## 4 Masterplan & Public Realm

# 6 Comparison Drawings

The following pages contain a series of comparison drawings to allow the amended design changes to be reviewed directly alongside the original approved planning drawings.

6.4.4 Section 4

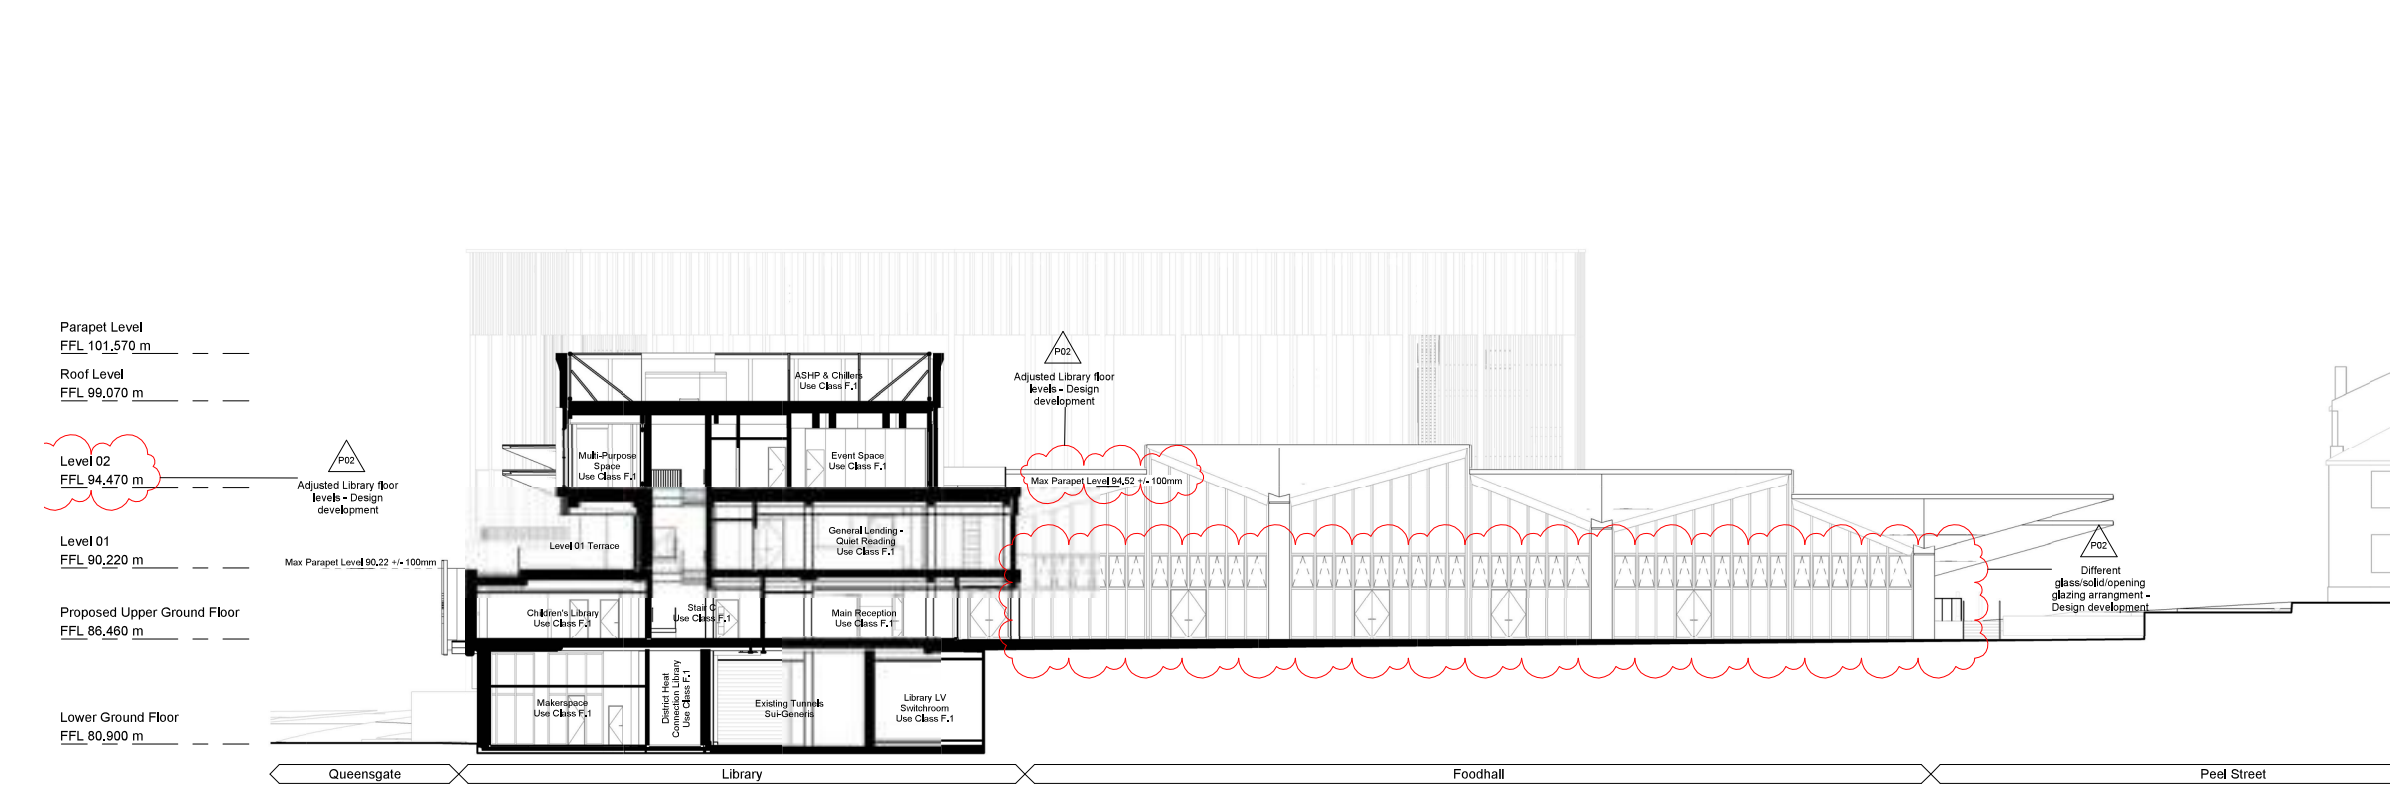
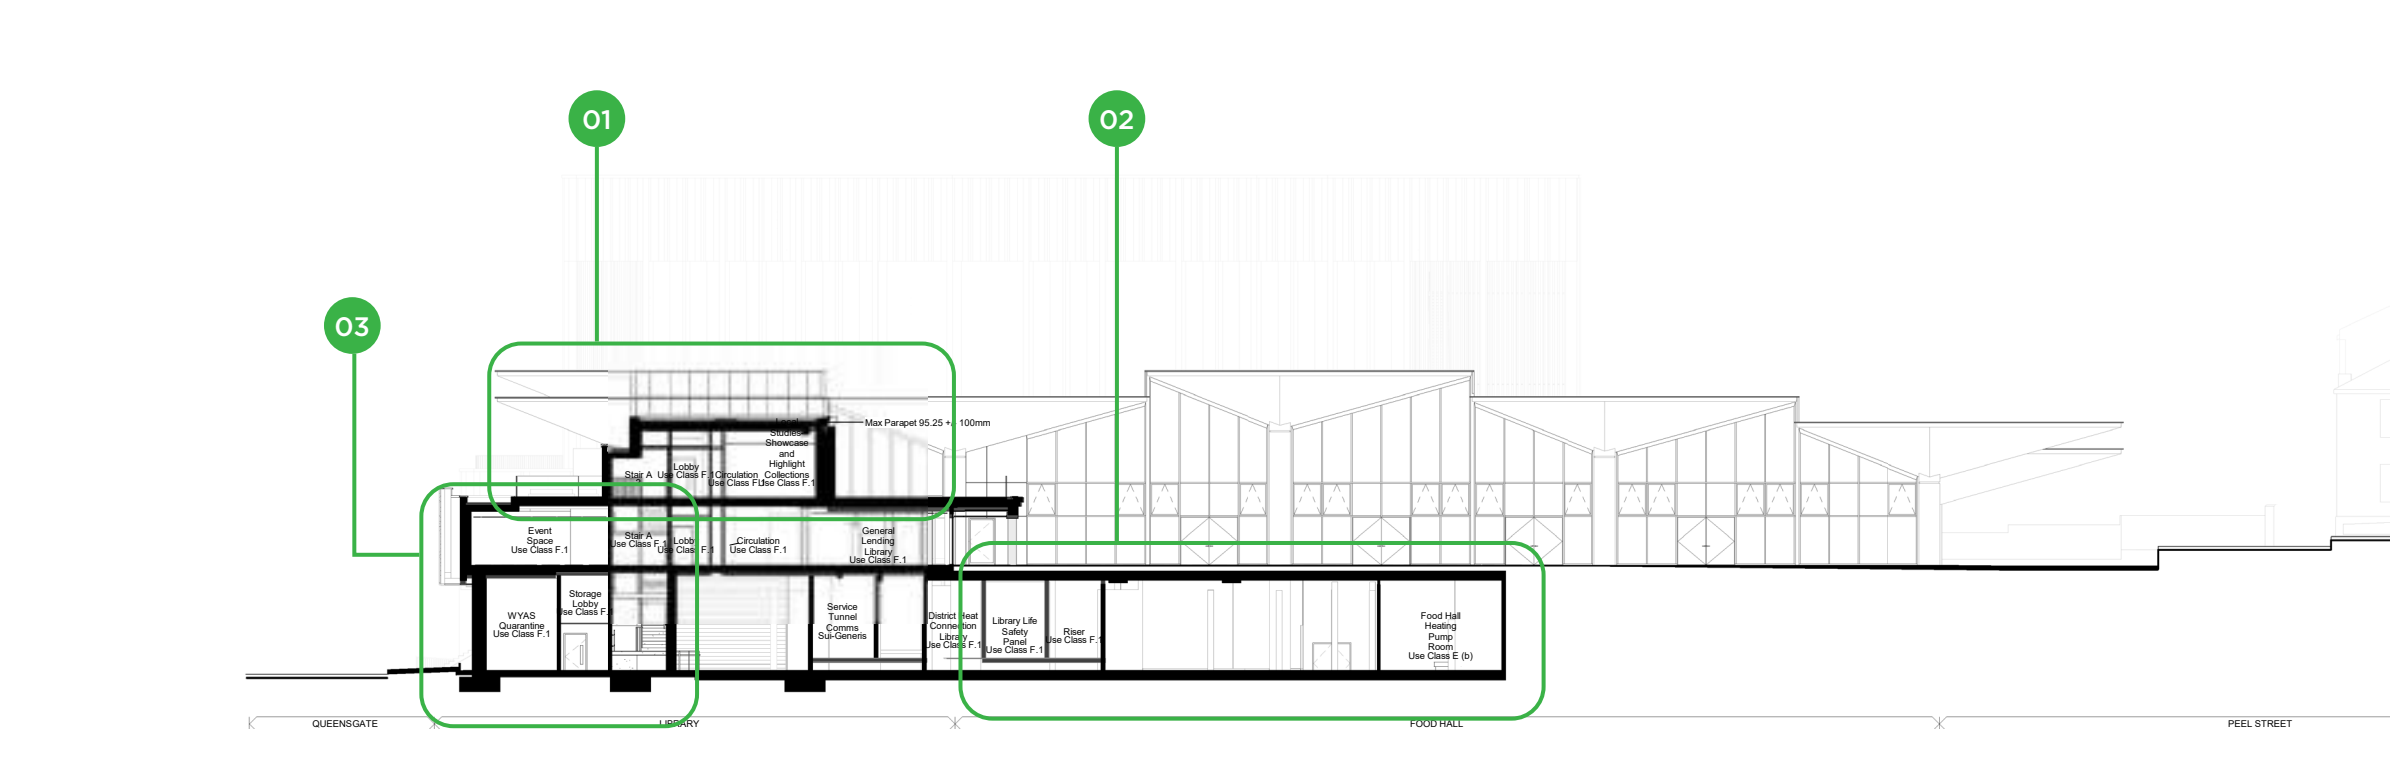
- 01 Omission of accommodation at second floor (event space and multi-purpose room) and relocation of plant enclosure down to this level.
- 02 Area of retained structure including retaining walls/columns/foundations/slab (at lower and upper ground floor).
- 03 Relocation of majority of Library storage to this level (higher floor loading and floor to floor height).

Original Planning Approved Plan

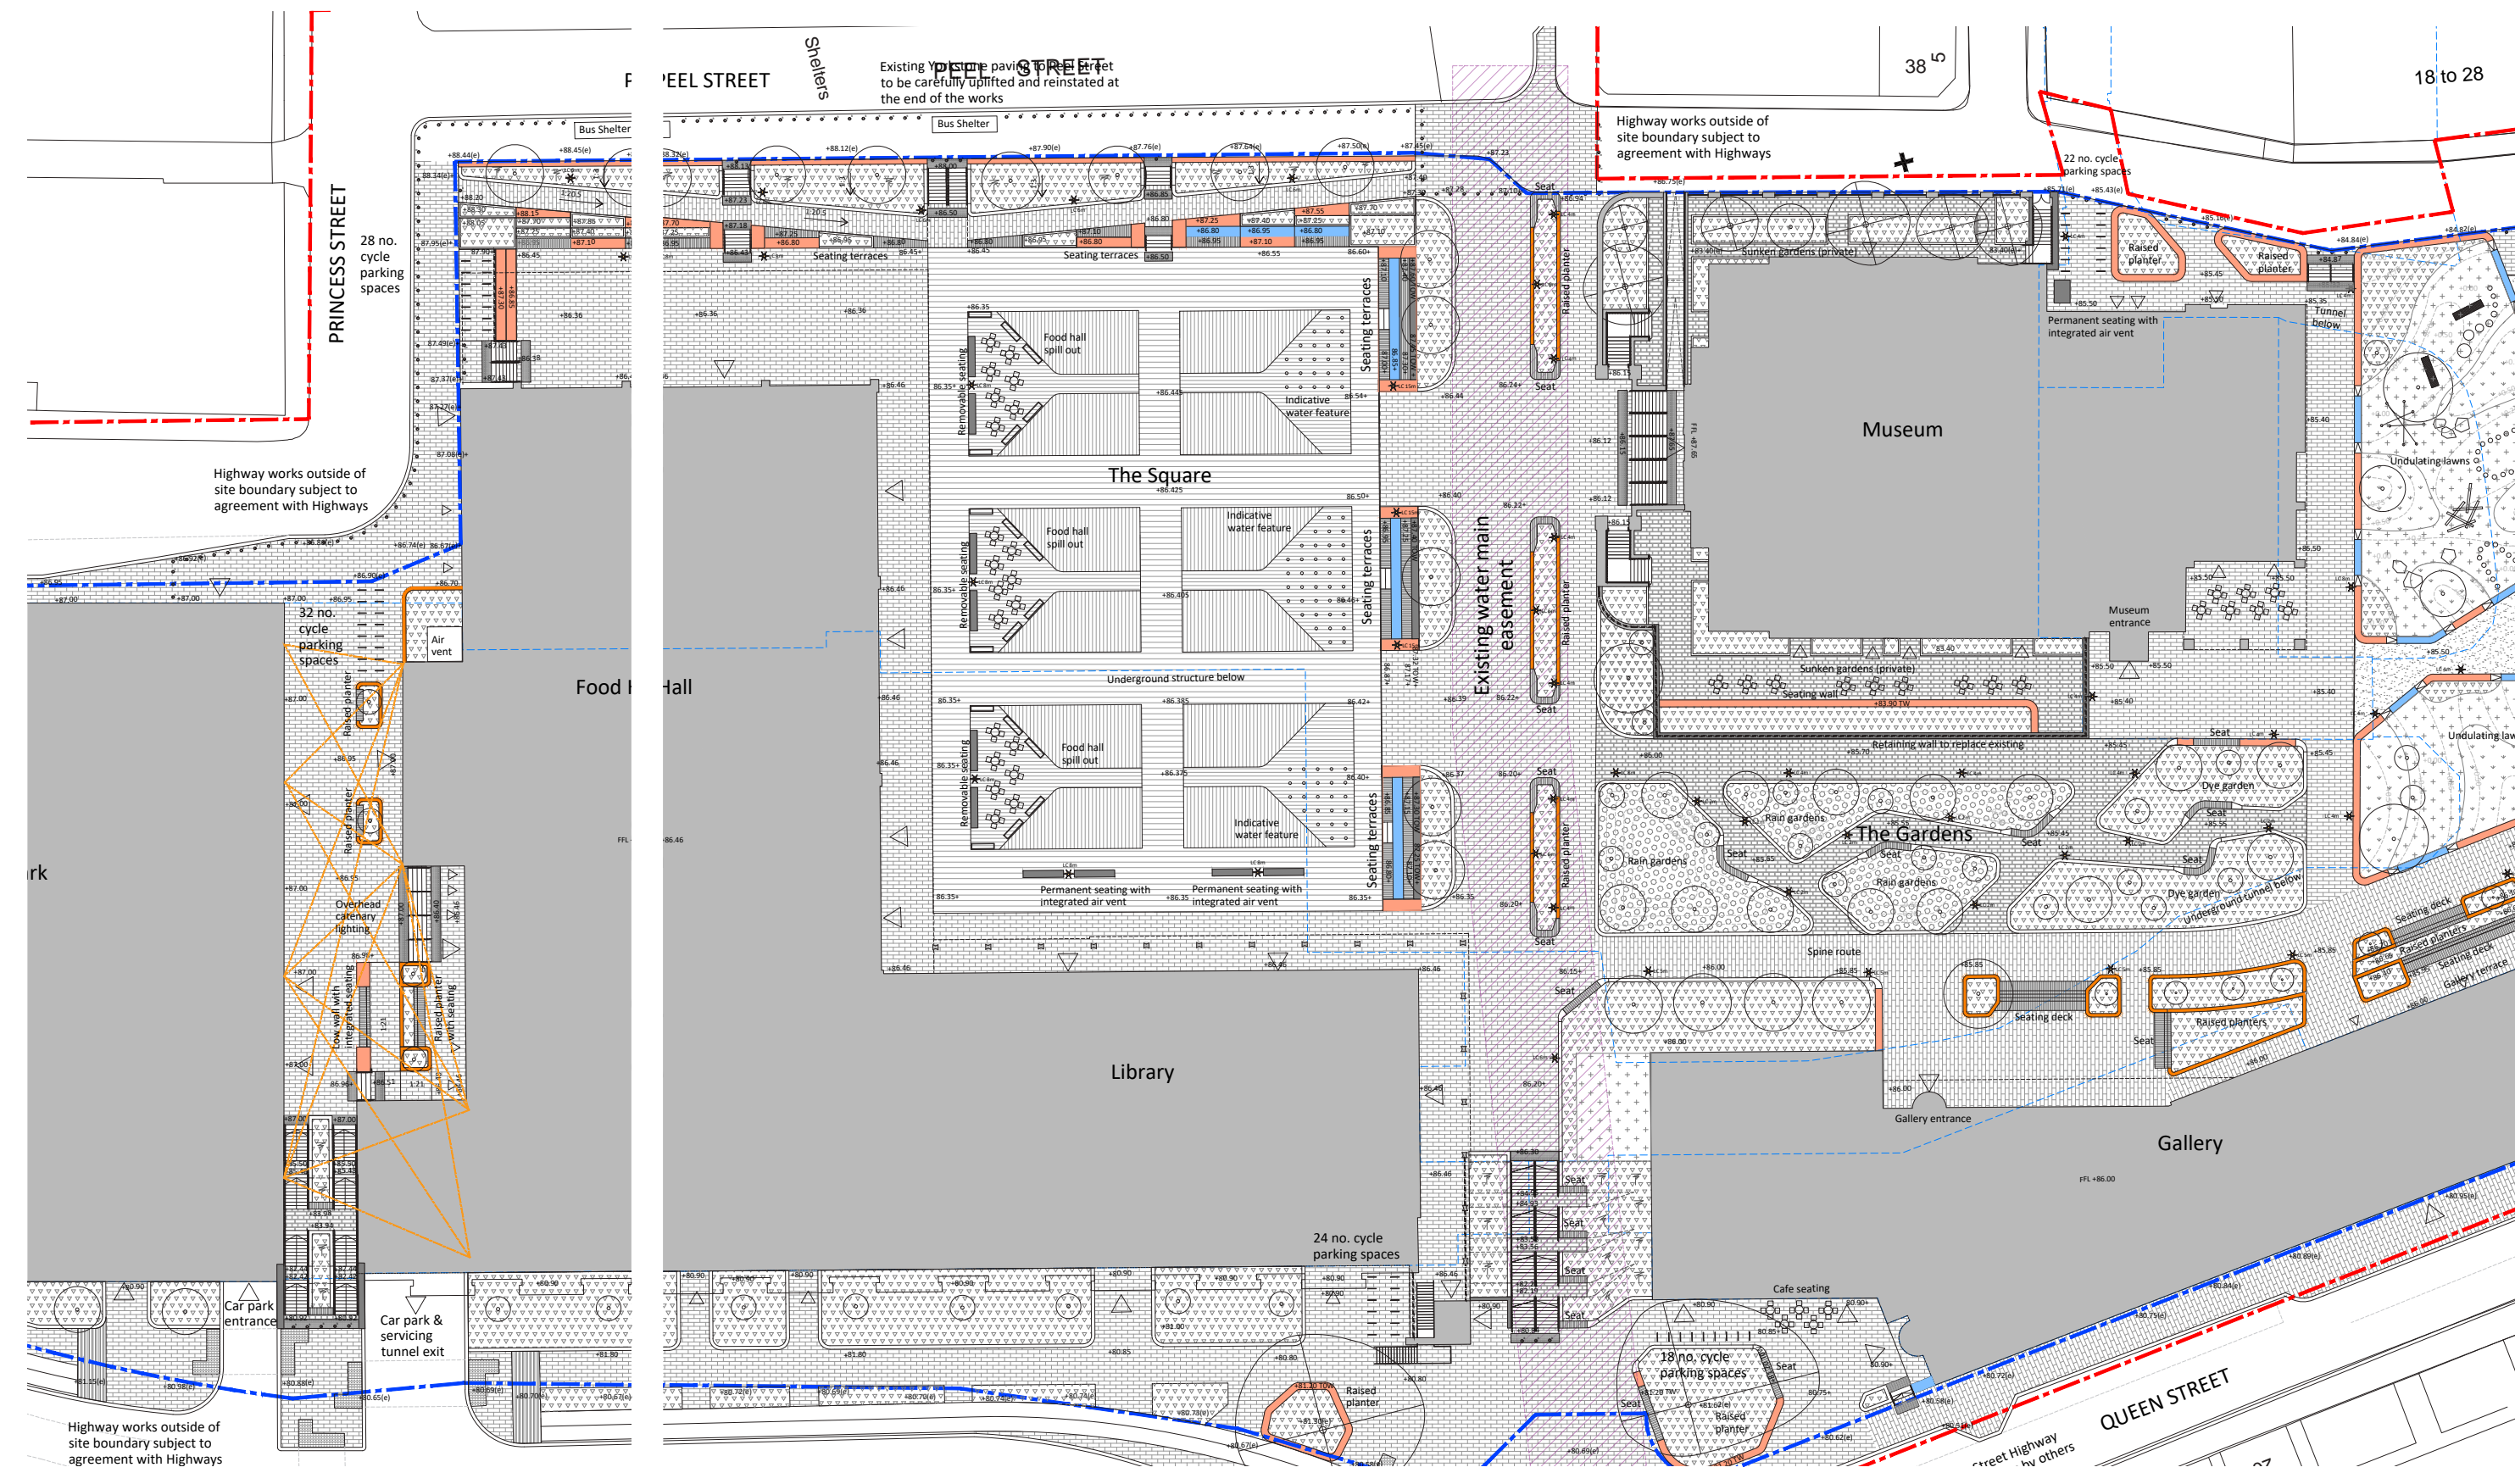
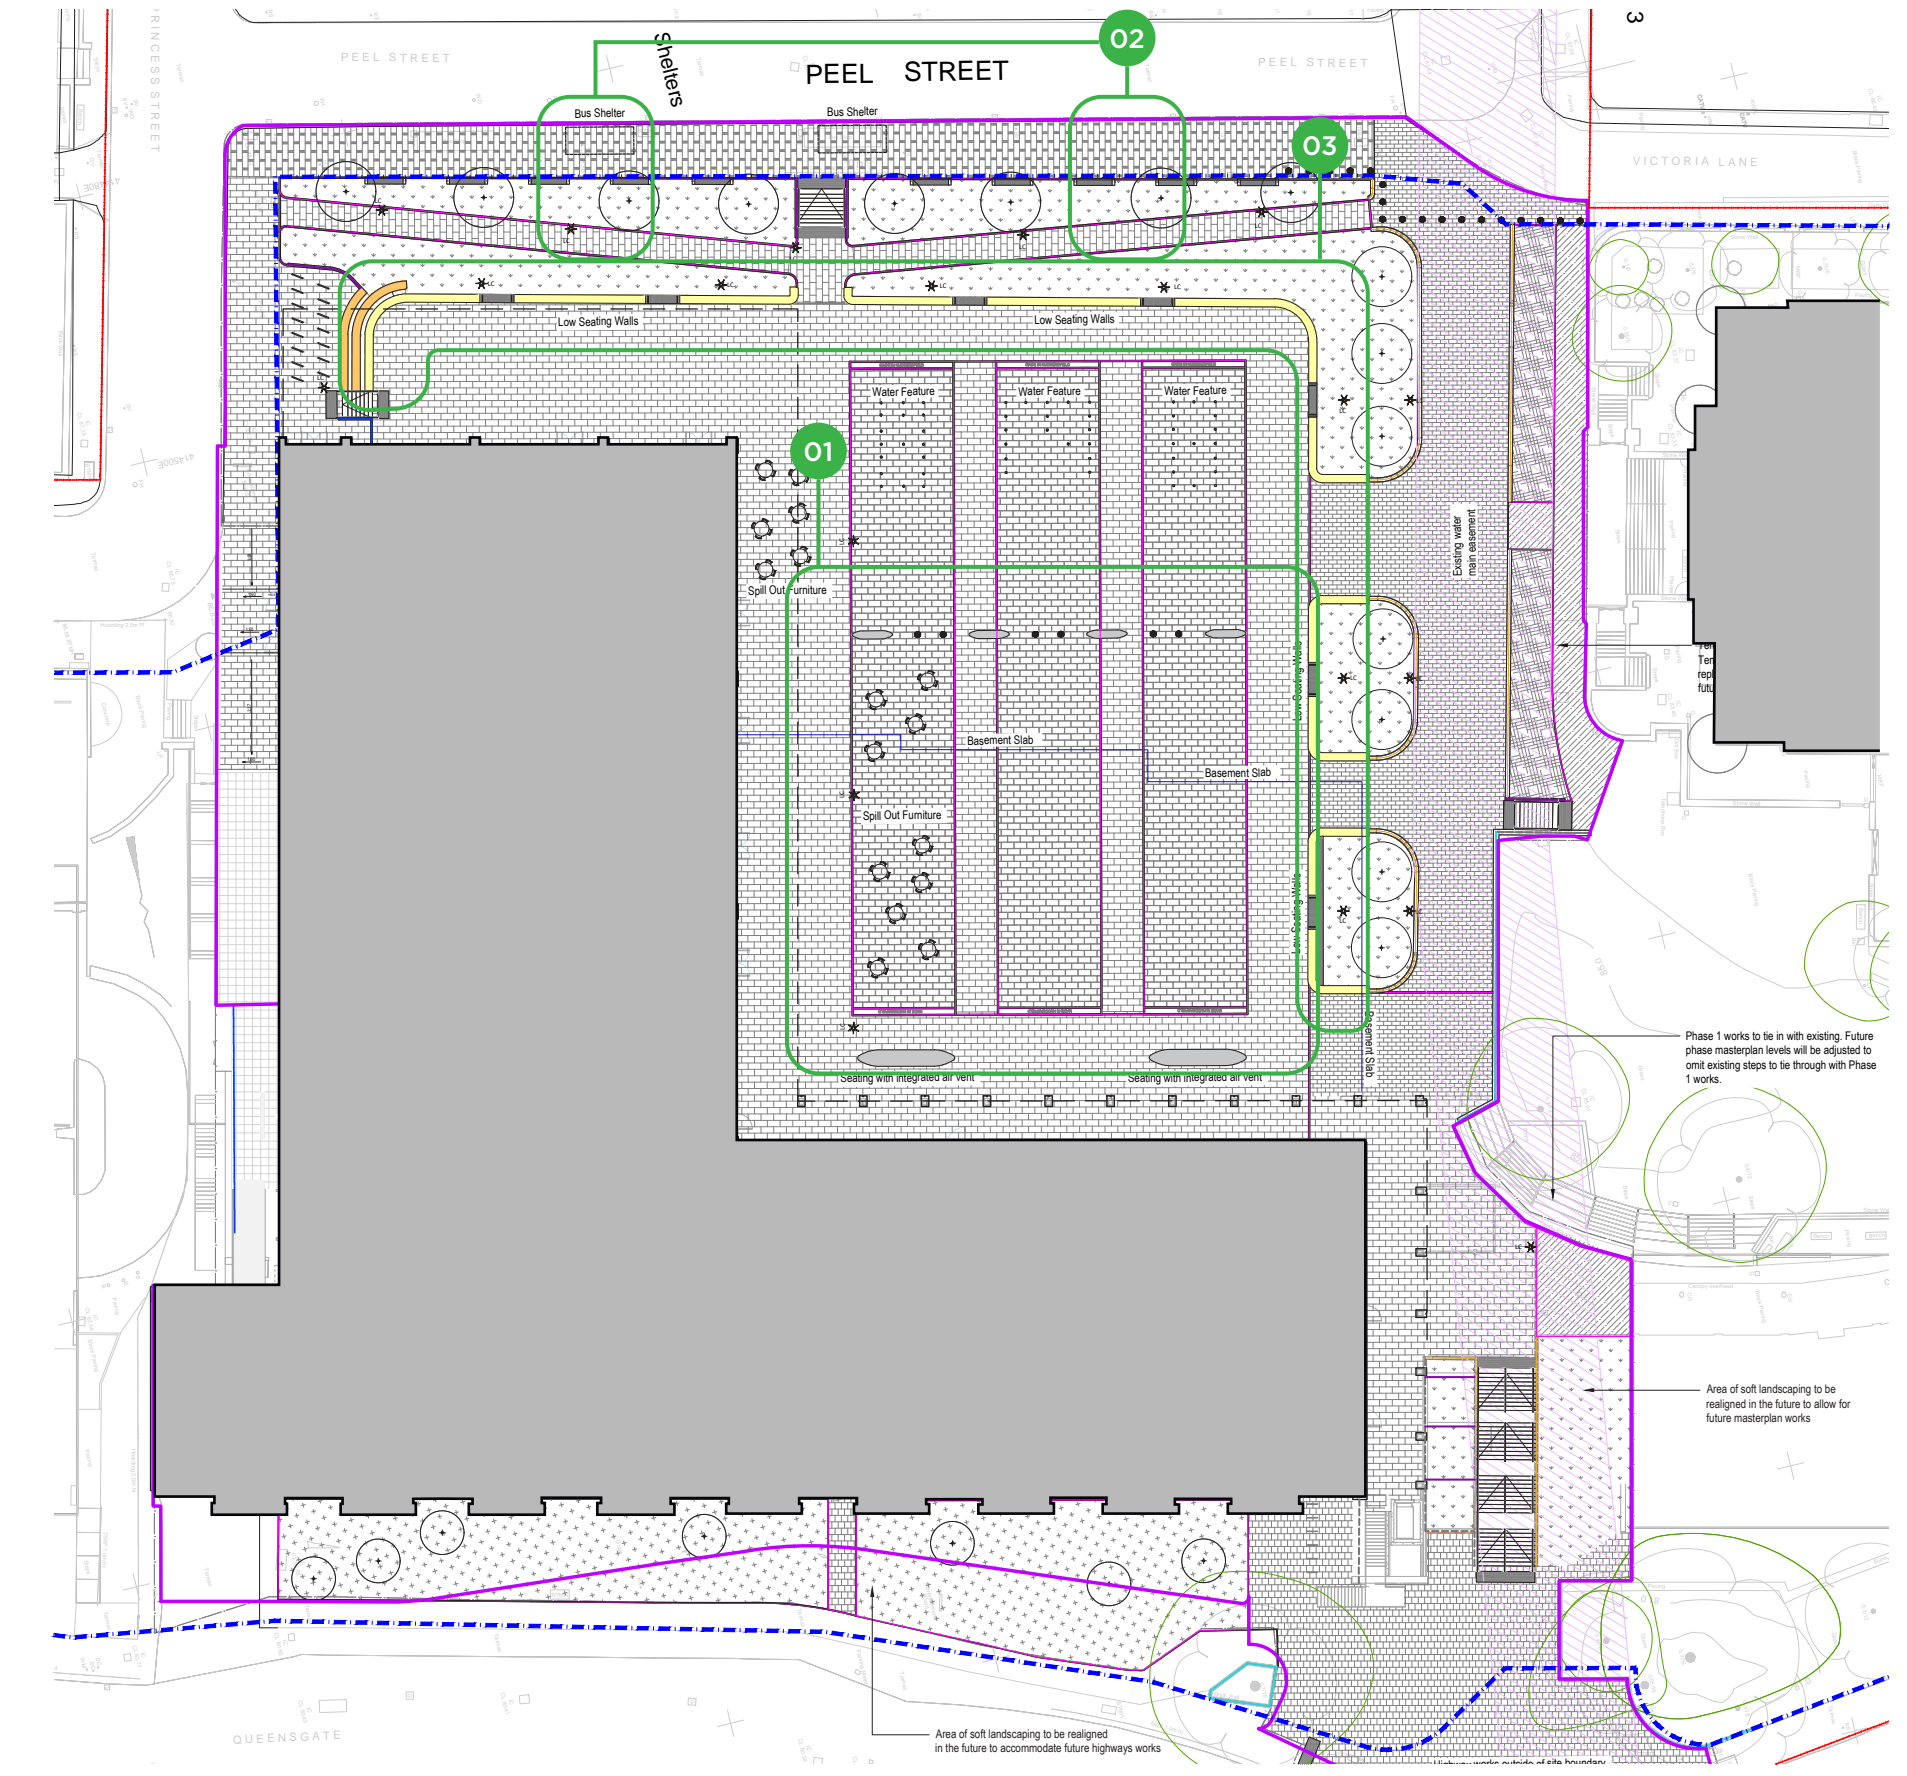
- 01** Omission of water features and restriction on loading (due to retention of existing structure below).
- 02** Omission of steps to plaza.
- 03** Reduction of one stepped seating and increase in soft landscaping.
